RECEIPT DATE: 7-17-19 **ONSITE SEWAGE DISPOSAL SYSTEM** P 565556

APPROVAL DATE: 11/14/19 ST **PERMIT: CONSTRUCTION** A _____

PROPERTY ADDRESS: 2141 MILLERS MILL ROAD, COOKSVILLE, MD 21723

SUBDIVISION: PRINCETON MILL LOT: 3 TAX ID: 04-596593

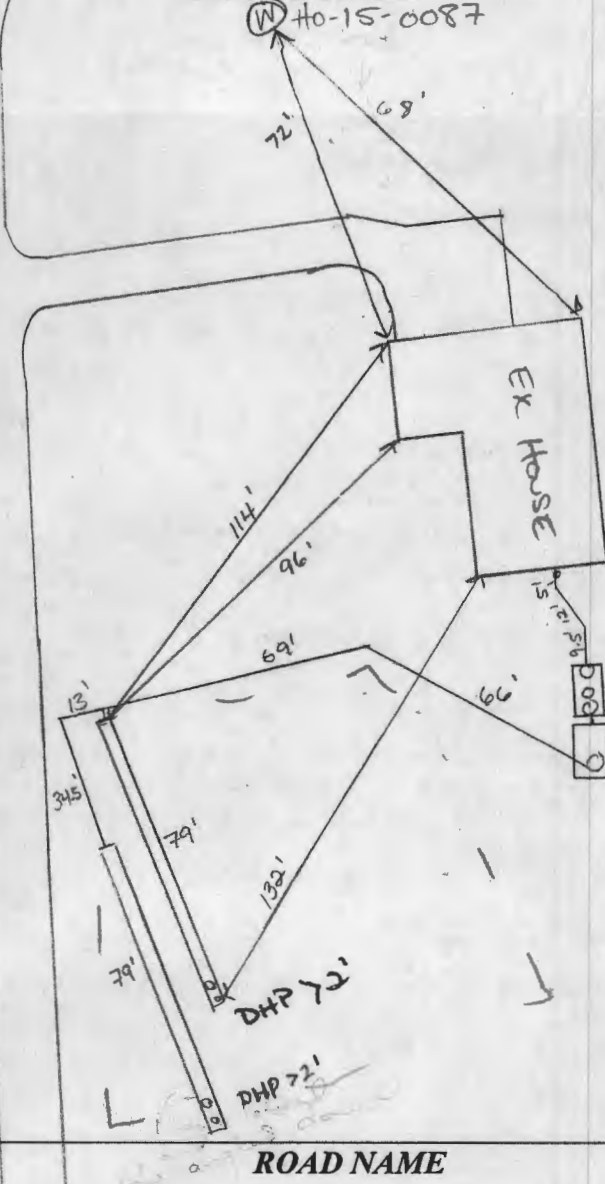
08/02/2019 TANK AND SDA STAKED. TANK ok TO SHIFT DOWN HILL TO AVOID TREE. TRENCHES NOT STAKED. REINSPECTION TRENCH LAYOUT. OPEN TRENCH FOR LATERAL OR

* 08/16/2019 CONFIRM CONTOUR AND DESIGN OF TRENCHES. OK TO START. (P)

INSTALLATION: 08/16/2019 SHC SEWER LINE AND SEPTIC TANK SET. (PM) PUMP TANK SET. * (P) 8/19/2019 FORCE MAIN INSTALLED LOWER TRENCH IN CONSTRUCTION. CONTRACTOR OPTED NOT TO HAVE OPEN INSP FOR LATERAL OR AFACE. OK TO ASSUME RISK UNTIL PUMP TEST. (PM) LOWER TRENCH COMPLETE COVER OBS PERFORATIONS ABOVE AGGREGATE. (P) 08/20/2019

UPPER TRENCH COMPLETE. TRENCH DESIGN WAS APPROVED. W/O HALF HOLE SPACE BETWEEN LATERAL AND END OF TRENCH. REINSPECT P/A. (P) (PM) ELBOW PRIFICE CALLED OUT AND NOT TOWARD END OF TRENCH. (P) 11/14/19 P/A and BAT passed. Alarm in basement, separate

breakers. Distal head pressure >2'. (P)

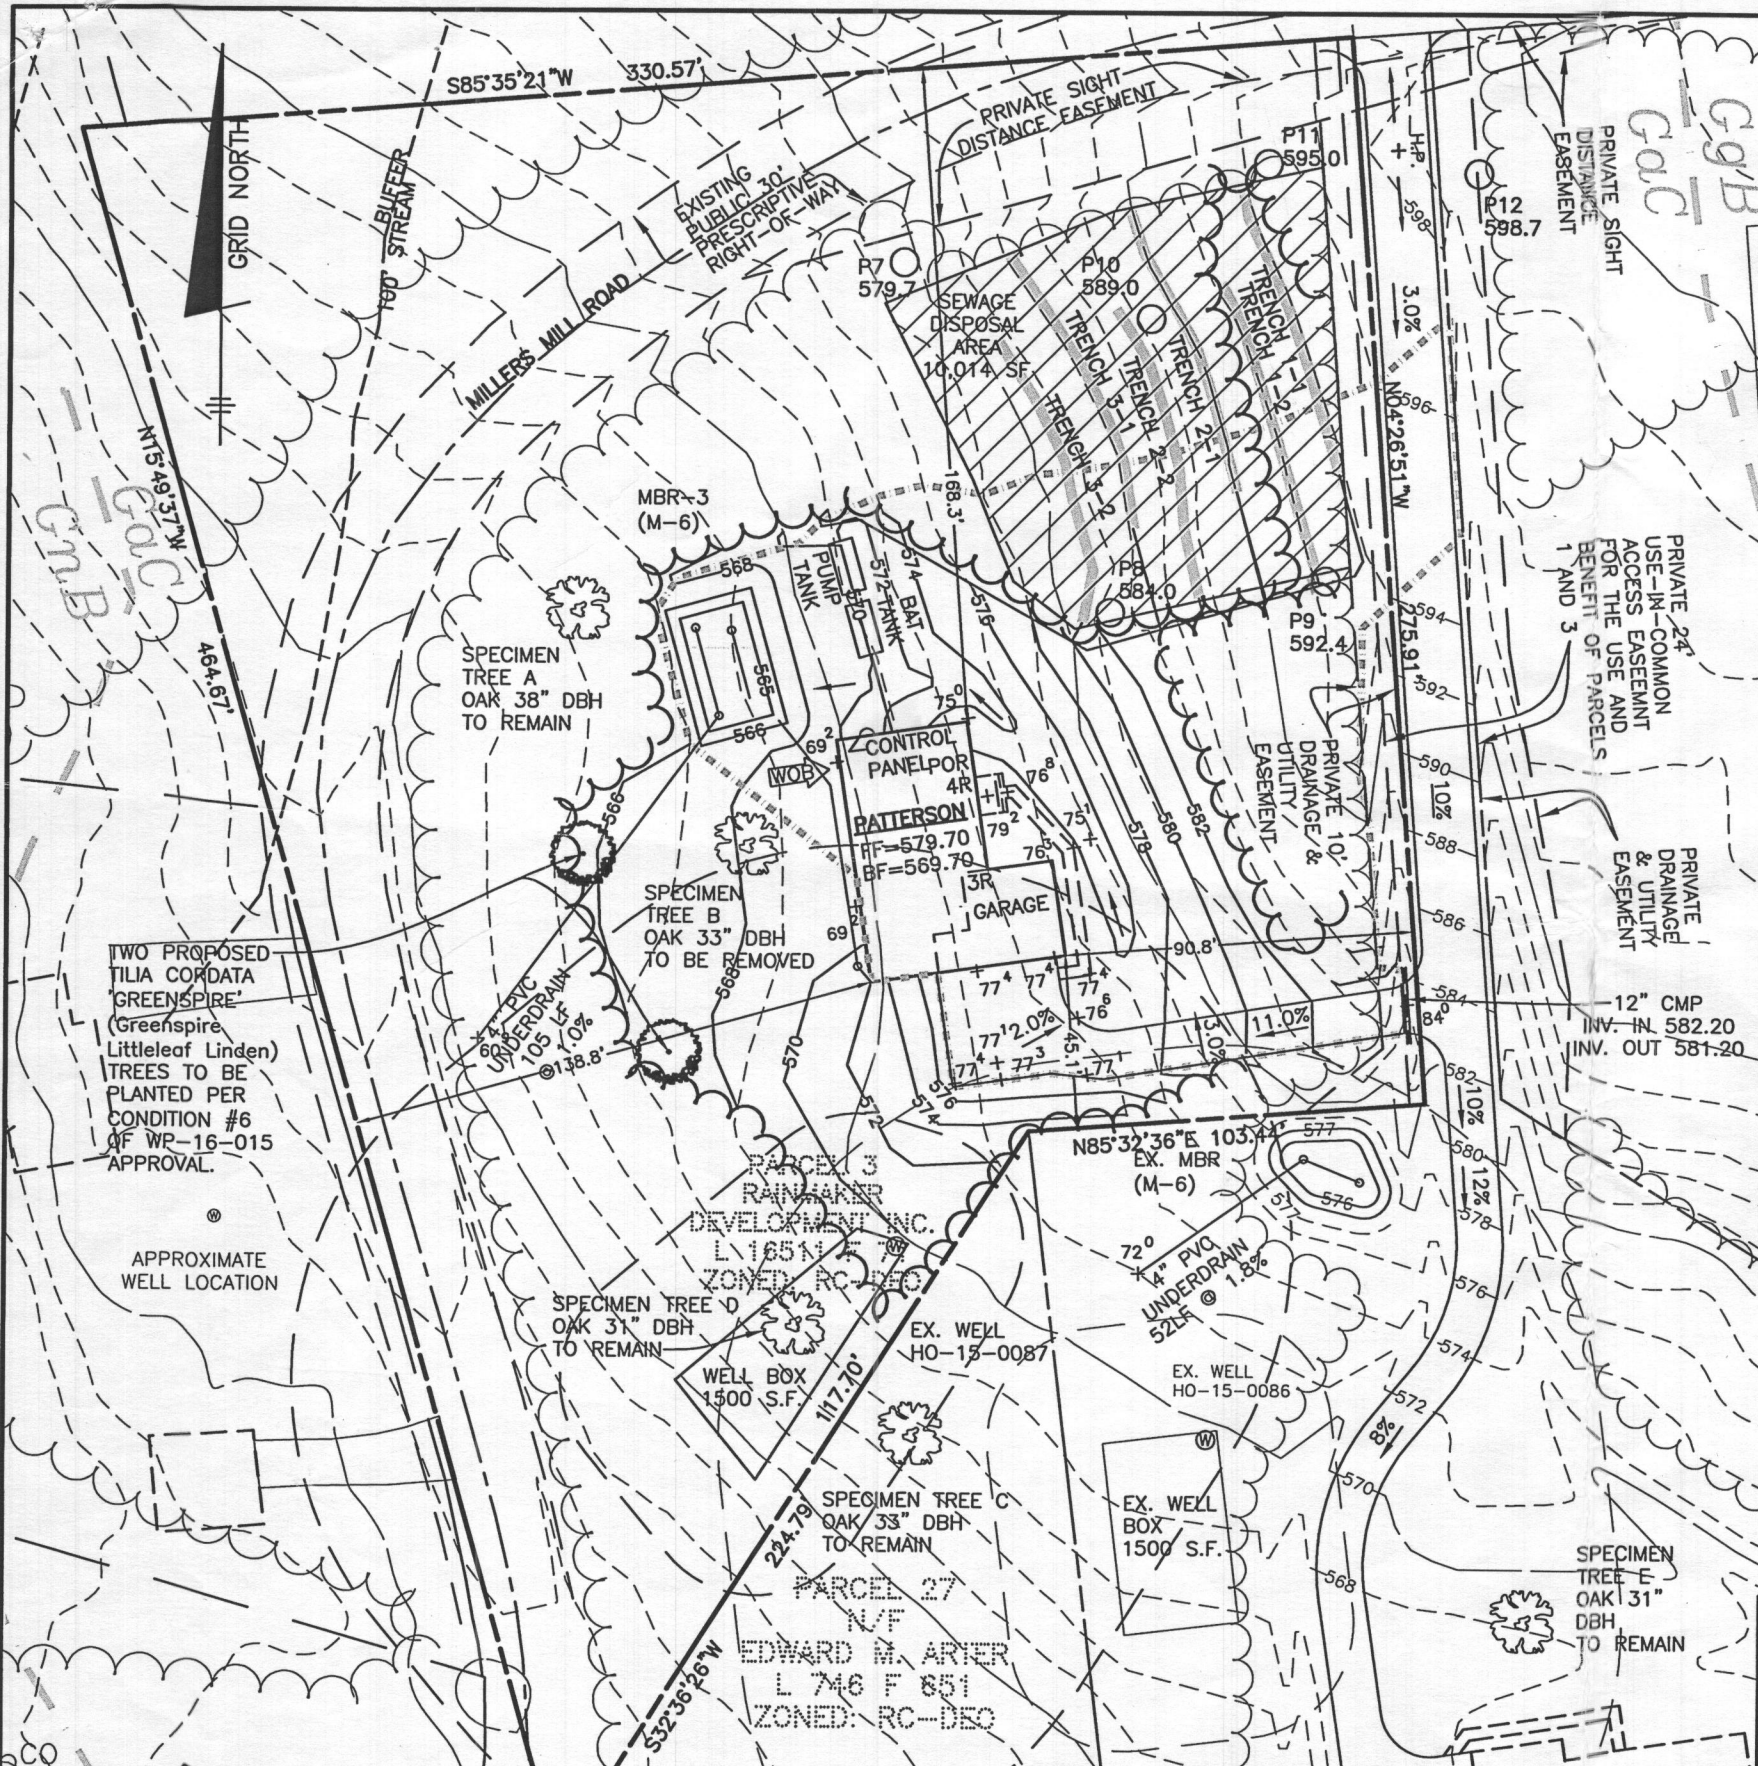
I have reviewed the BAT plan submitted for Princeton Mill Parcel 3 and have no comment at this time. Approval for the plan may be granted when a formal Building Permit is submitted. A review of floor plans is required by the Health Department. If you have floor plans for proposed construction on Parcel 3, you may submit them to me (by Email) as a PDF, or deliver hard copies to my attention at the Bureau of Environmental Health desk.

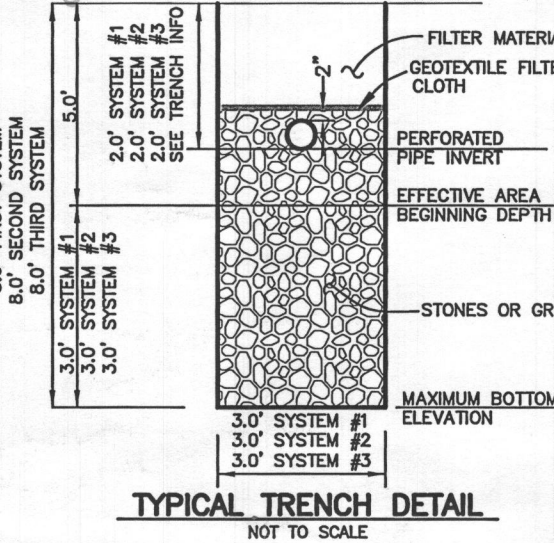
Howard County Health Department
 calculations OK
 USE BN163 (0.5hp) pump
 R. Bricker
 Signature
 4/5/2019
 Date
